CITY OF ALBUQUERQUE

Re: Solare Charter School, Phase 1
8801 Gibson Blvd SW
60-Day Temporary Certificate of Occupancy
Transportation Development Final Inspection
Engineer's/Architect's Stamp dated 6-17-19 (M09D031)
Certification dated 2-18-20

TCL

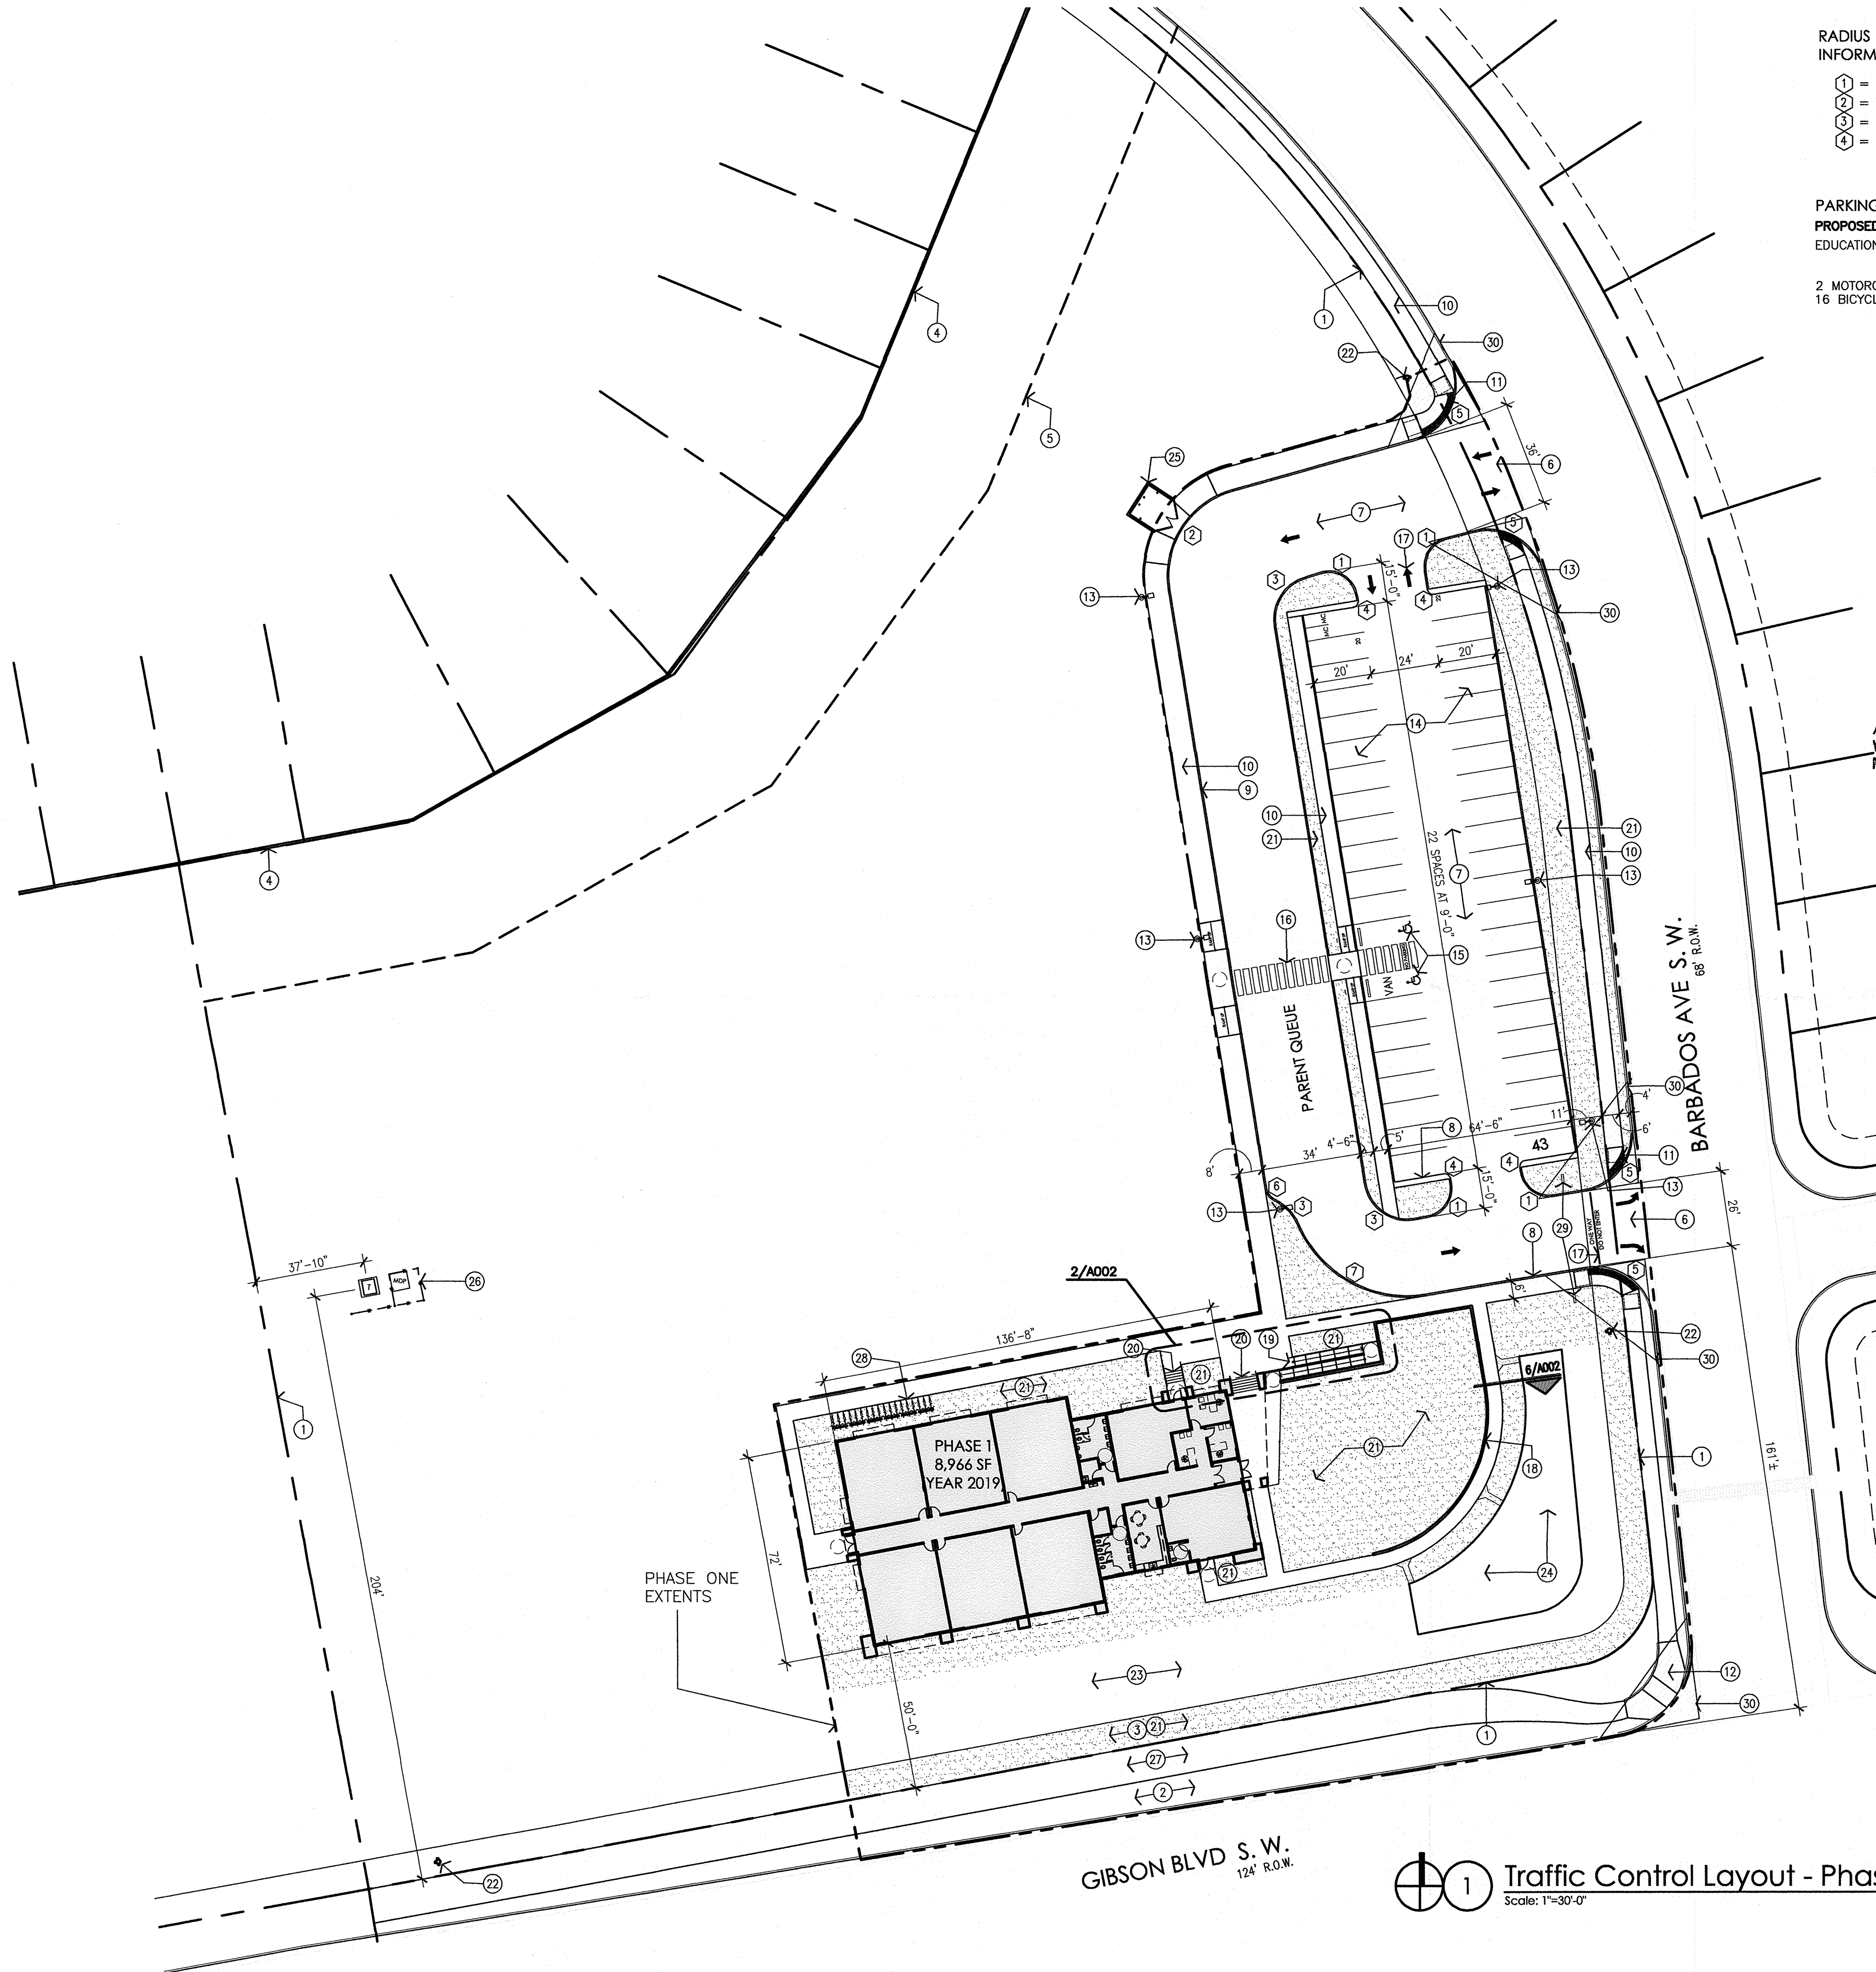
- Please complete bike trail keynote #27.
